architect				
Lifschutz Davidson Sandilands				
Island Studios, 22 St. Peter's Square, London W6 9NW T +44 (0)20 8600 4800 F +44 (0)20 8600 4700 mail@lds-uk.com				
project	drawing title			
16-19 Gresse Street, London, W1	Basement Level Shower and changing facilities			
client	scale at A1	scale at A3	drawn	date
Derwent Valley Holdings	1:25	1:50	SPC	05.06
	job no.	drawing	rev.	
	0382A	A2015	E

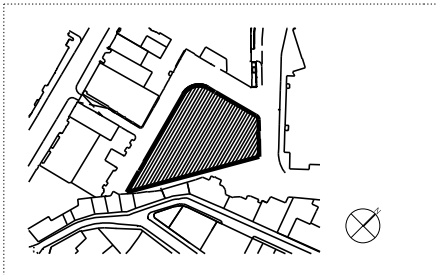
date	rev	revisions
23.06.06	A	XXX
23.07.07	B	Issued for construction
06.08.07	C	Gullies and soil vent pipe locations revised. Shower tray and stud wall locations revised. Shower ramped bund wall added. Setting out dimensions updated. Access panel to basin drains added. Issued for construction.
28.01.08	D	Blockwork layout revised in line with Meica drawings. Door B-019 relocated. Accessible shower and WC wall widened to allow for soil and vent pipe
31.03.09	E	Glass shower screen detail specification clarified as Majestic Standard Rio code SDP1200 no anti limescale coating. 10mm recessed ss profiles at fixed panel. 112mm short D handle to ss plate hinged door with clear pvc bottom edge seal 195. Drylined and mosaic tiled short side walls omitted.
